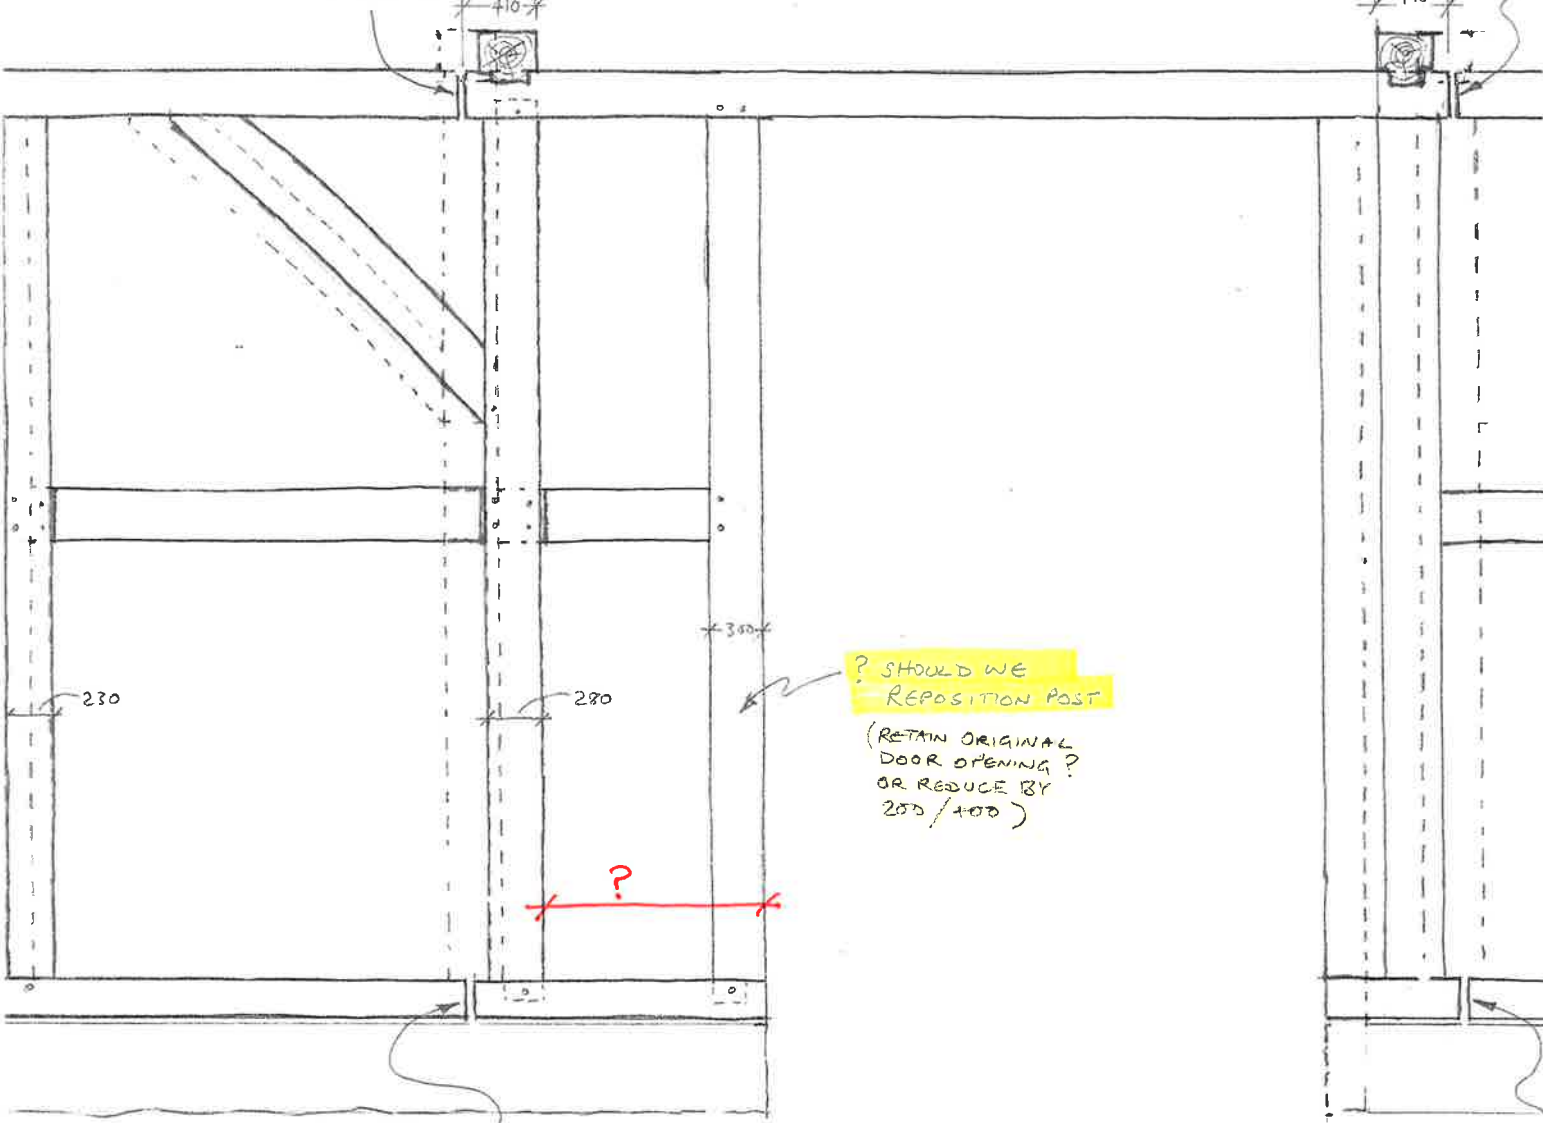
CUT THROUGH
WALL PLATE

CUT THROUGH
WALL PLATE

? SHOULD WE
REPOSITION POST
(RETAIN ORIGINAL
DOOR OPENING?
OR REDUCE BY
200/400)

CUT THROUGH
CILL PLATE?

OR MAKE ??
NARROWER.??

? WE DO NOT KNOW HOW
THIS OPENING RELATES
TO YOUR DOORWAY INTO
THE BUILDING.
